COMMENTS ON THE DRAFT APPC NPDES PERMIT FILED BY PREPA

Re: Comments on Draft NPDES Permit PR0001660 – Aguirre Power Complex

**Comments to the Draft
National Pollutant Discharge Elimination System Permit
Aguirre Power Plant Complex
NPDES Permit No. PR0001660
July 2010**

Figure 5-33. Isotherms of Maximum Temperature at the Surface due to Cooling Water Discharge to Jobos Bay at an Average Ambient Temperature of 86.75 °F

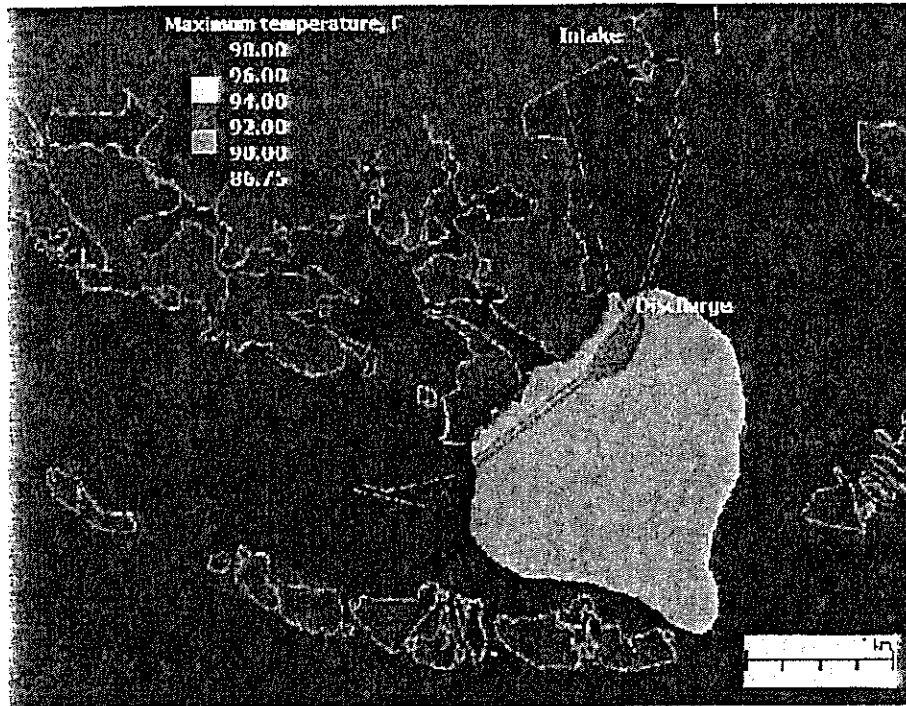
2. An irregularly shaped mixing zone whose boundaries are defined by a Figure and Table (to be provided by PREPA if this comment is accepted) which corresponds to Figure 5-33 of the APPC 316 Demonstration Study. This figure will also designate at least 4 boundary-related sampling points and one or more background water temperature sampling points. **Basis** - See above and section 5.2.3 and Appendix B of the APPC 316 Demonstration Study.
